Consumer's Exhibit #1 (Kane)

Subject: Midland; Units 1 & 2

Questions on NRC Review Policy of Cooling Ponds (Cat II)

DISCUSSION OF THE APPLICANT'S POSITION
ON THE NEED FOR ADDITIONAL BORINGS
FOR
MIDLAND PLANT UNITS 1 AND 2
CONSUMERS POWER COMPANY
DOCKET NUMBERS 50-329 AND 50-330

Figure 3
(See Reference 1)

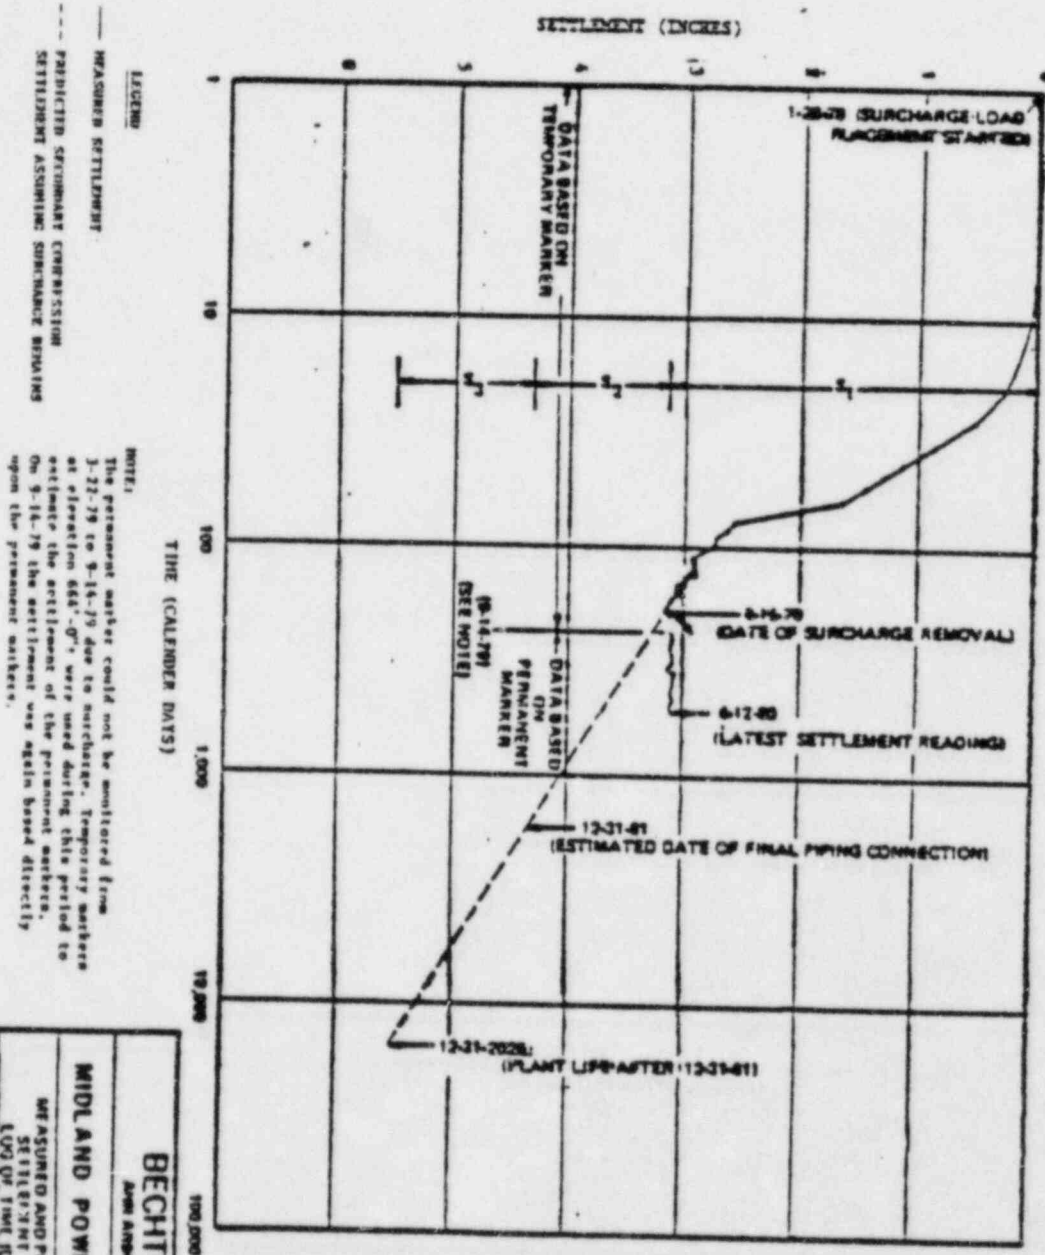
Primary settlement occurred rapidly and settlement measurements indicated secondary consolidation was occurring as verified by the straight line on the semi-log plot shown on Figure 3. This figure is typical of all the settlement curves shown in Figures 27-6 and 27-51 through 27-78 which exhibit a straight line settlement .

Figure 4
(See Reference 1)

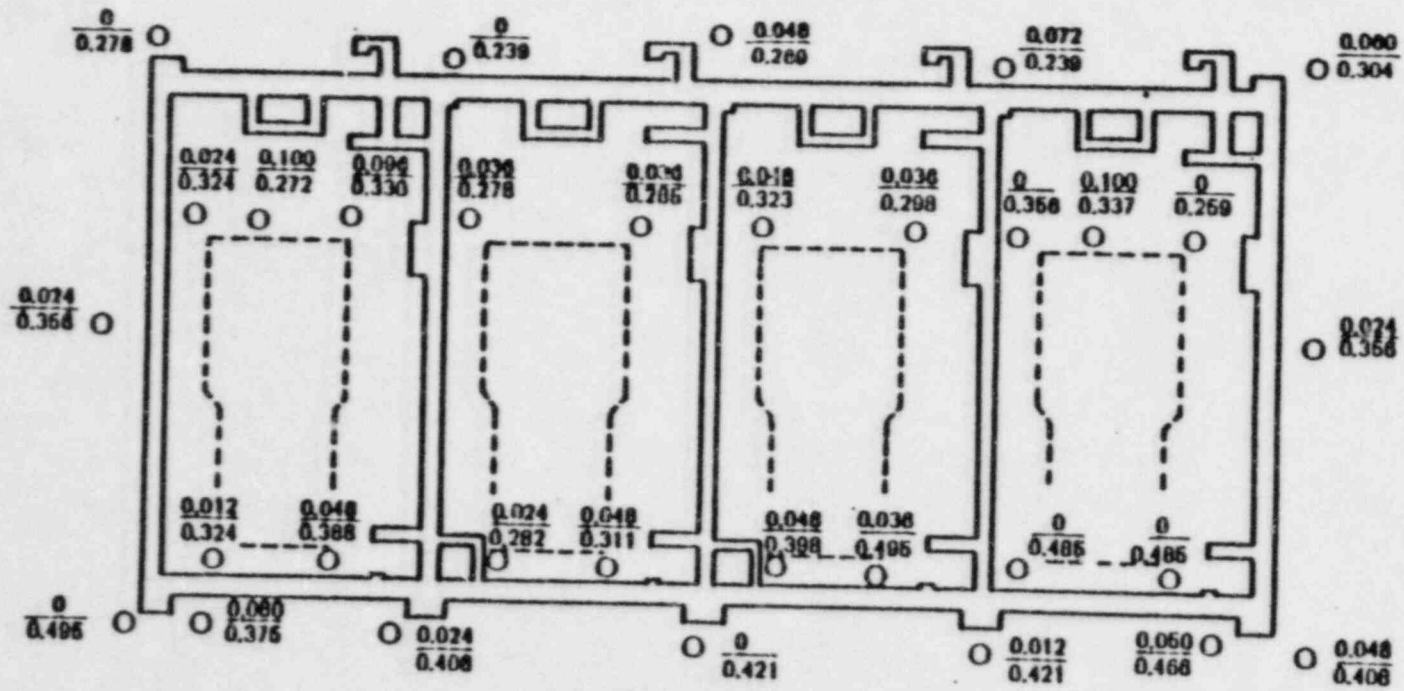
during secondary consolidation. This behavior has been recorded on many projects including the Chicago Auditorium where this straight line secondary behavior has been observed for 60 years. Settlement trends based on rates experienced while the surcharge was in place were extrapolated to predict maximum settlements expected to occur over the life of the plant. This prediction is based on the conservative assumption that surcharge loading conditions remain for the life of the structure. Settlement measurements made during the period between September 14, 1979, and June 12, 1980, show that, on the average, the building experienced less than 0.1 inch of settlement as shown on Figure 4.^(4,7,8)

○ Proposed CoE boring locations (approximate)

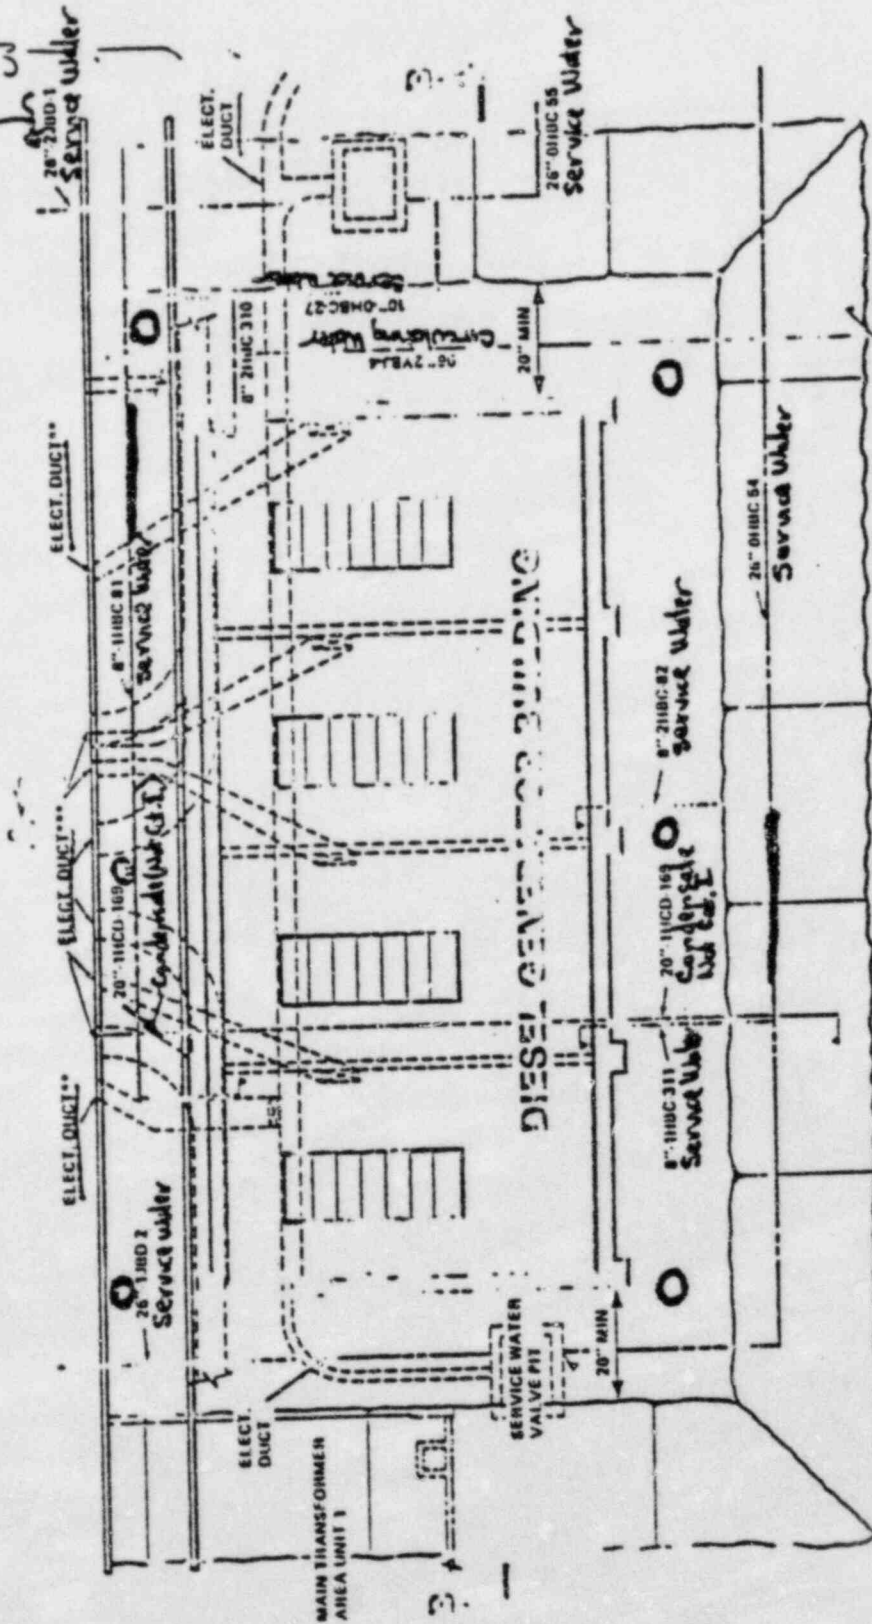
d. Plant Area Borings - Some borings must be taken under the Radwaste and Turbine Buildings to determine if unwatered pockets exist or persist. Suggested boring locations would be as indicated on the attached map. Further investigation could be needed after the results of these borings are obtained. No borings presently exist in these areas. The borings should be cased or hollow stem auger borings with drive samples every 2-1/2 feet through the fill should be taken and converted to dewatering holes or used for piezometers (Holes 1, 2, 3, 6 & 7).

▲ COE Requested
Boring Locations
-for Pond Area

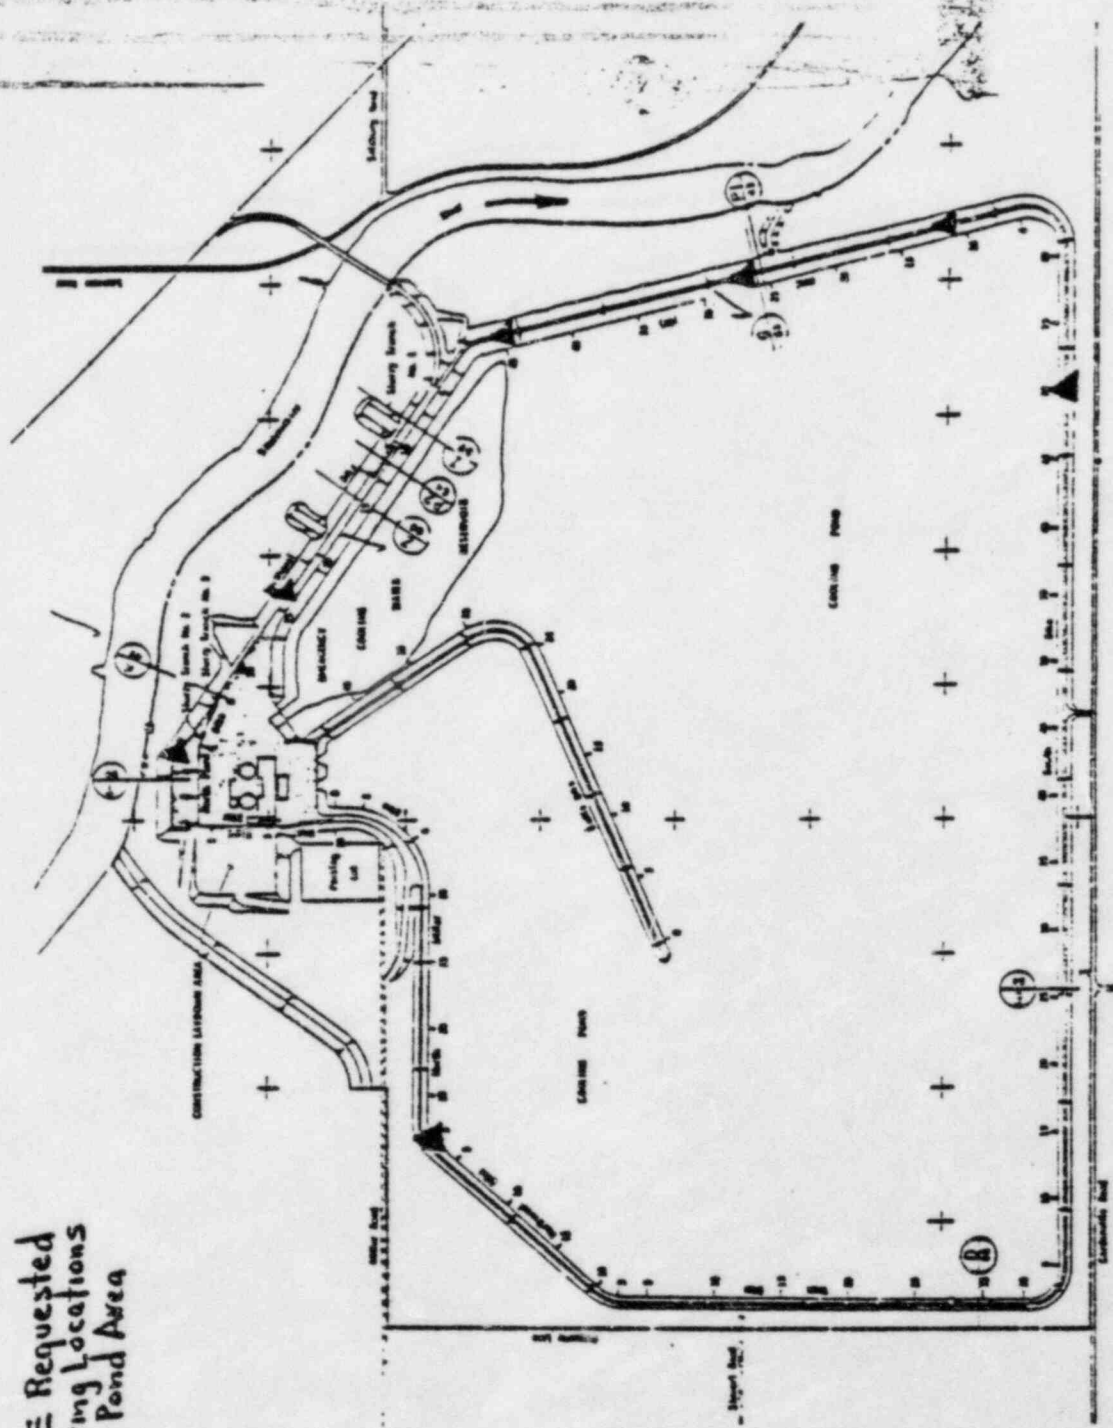
c. The questionable site area fill may have a counterpart in the cooling pond embankment which was constructed contemporaneously with the site fill. It is requested that exploratory continuous drive borings be taken at a number of points along the north and east embankments, omitting the slurry trench cutoff areas which are positively sealed. The approximate boring locations are as indicated on the attached map of the cooling pond. The tests on the soil samples obtained from the borings in the embankments shall include the following tests, unconsolidated, undrained triaxial shear tests, Atterberg limits and all soils classified according to the Unified Soil Classification System. The borings shall be sampled every 2-1/2 feet using a standard split spoon sampler. The hole shall be held open using a hollow stem auger or casing. Particular attention shall be paid to ground water conditions during and after completion of drilling. In the case of Hole 5, the boring should be drilled to the depth of the cooling pond bottom while the remaining borings need penetrate only 5 feet into underlying residual soils unless soft ground indicates a need for further hole penetration.
